TOWN OF KILL DEVIL HILLS

NOTICE OF PUBLIC MEETING

Subject: SITE PLAN REVIEW — 1106 Blue Jay Street — Proposed Professional Office Building (Dentist Office)

DRAWING TITLE	
UTILITY AND LIGHTING PLAN	
DRAWING NUMBER	SHEET NUMBER
C4	4 OF 8

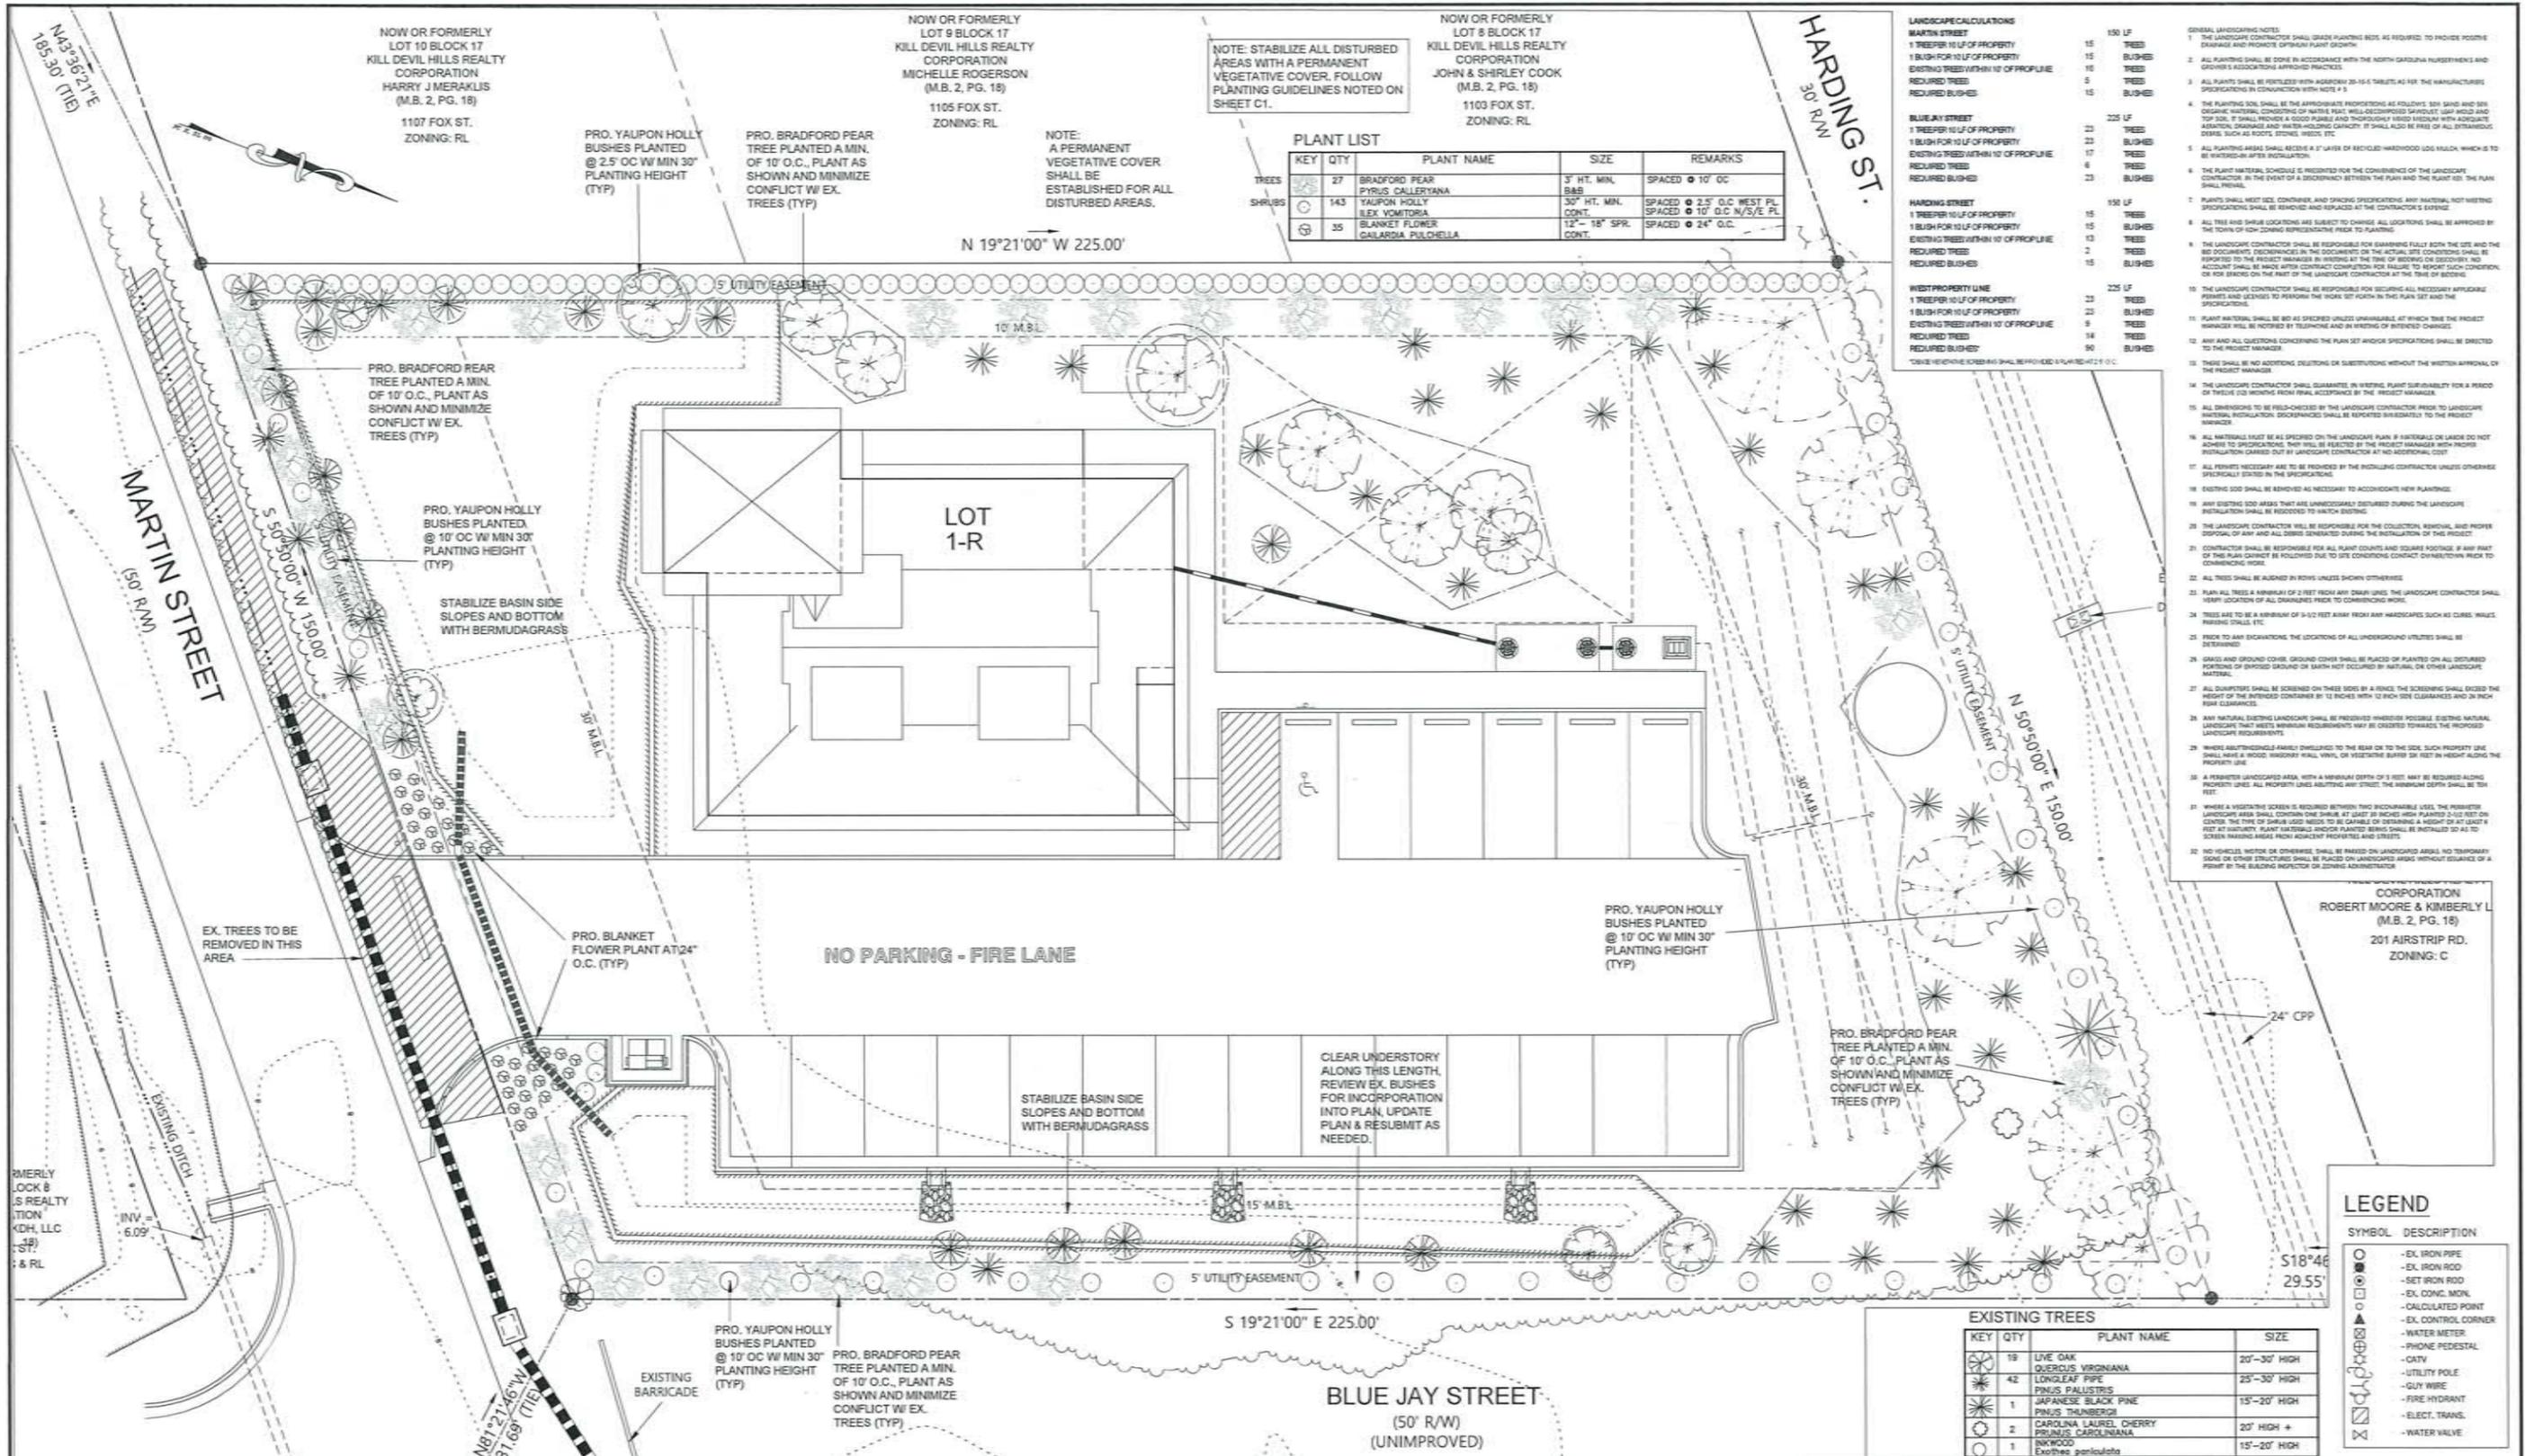
6. Utilities: Lighting plan required for the entire site. Plan submitted only includes the photometry for parking areas. *Answer- Photometric data has been provided for the site through to the property lines. Supplemental solar bollards have been provided along the sidewalk and depicted on Sheet C4 Utility Plan. The remaining photometry is depicted on a separate exhibit provided by the vendor.*

1. Show meter box and add "BY TOWN" to the "PROPOSED 1" METER". Answer: This information has been noted on the utility plan sheet.
2. Provide RPZ just downstream of the meter for the high hazard use. Answer: The RPZ is depicted on the utility plan.
3. Fees associated with proposed service is based upon the current fee schedule. Answer: Acknowledged.

1 FIRST FLOOR PLAN- 3,079 CONDITIONED SQUARE FEET
 SCALE: 1/4" = 1'-0"

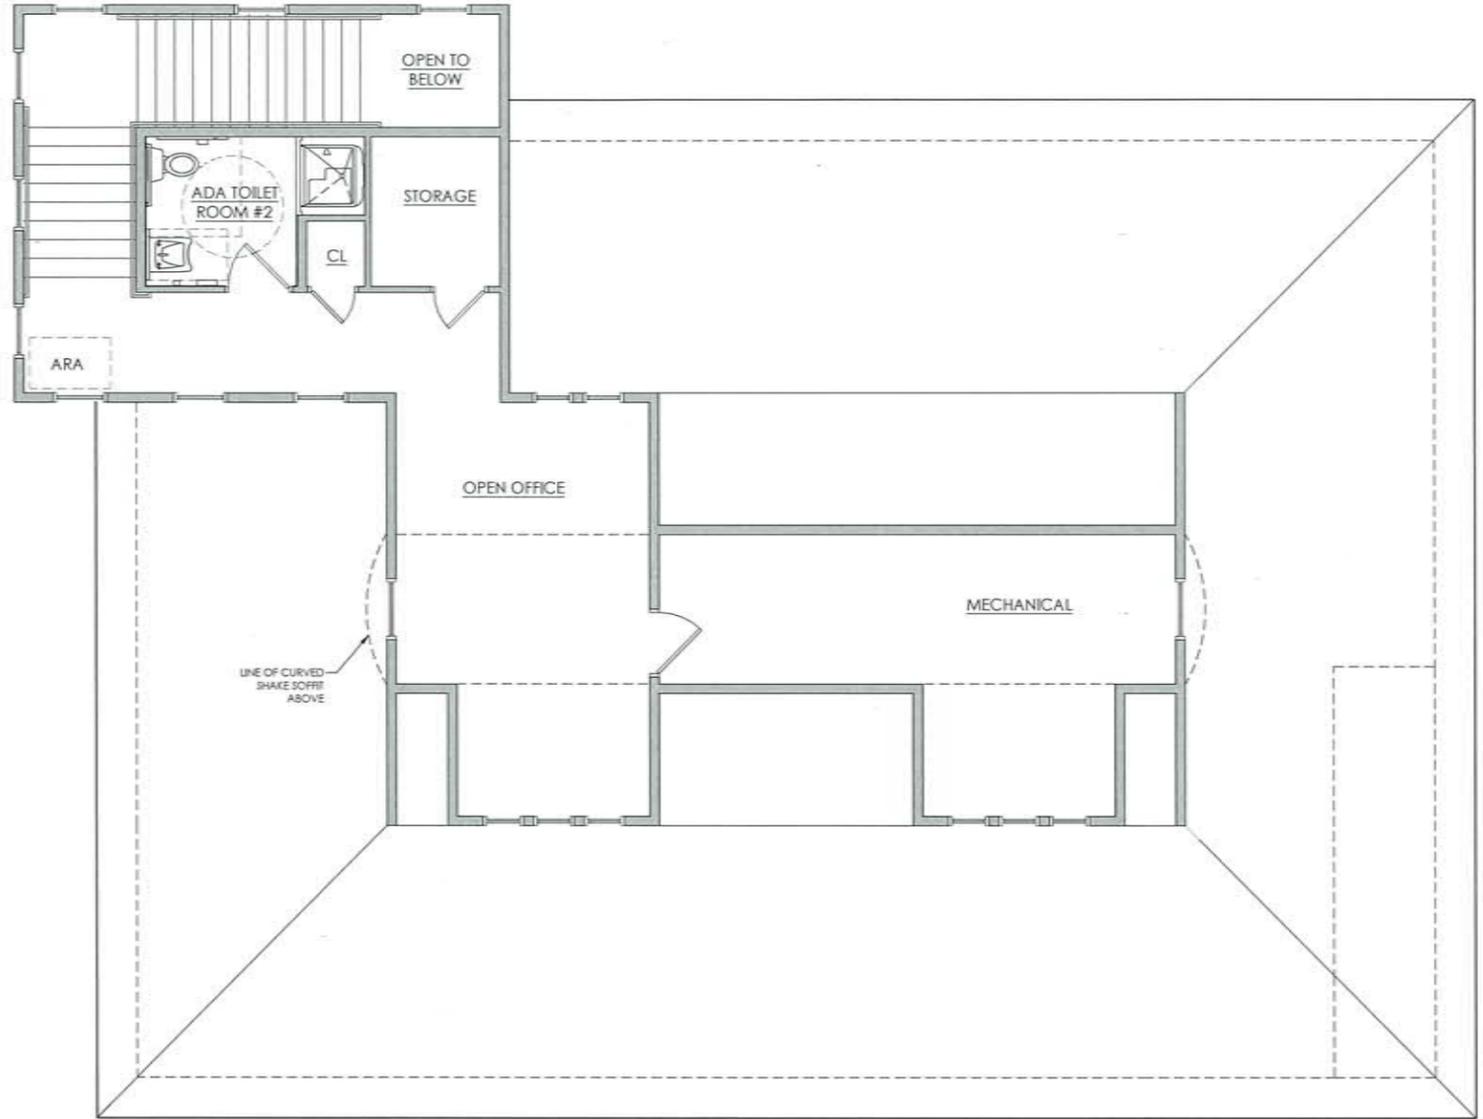
1. Directions of proposed elevations noted on floor plan A1.1.
2. Roof overhangs dimensioned on sheet A1.3
3. Roof heights from top plate to ridge dimensioned on sheet 2.1
4. Building materials noted on sheets A2.1 and A2.2.
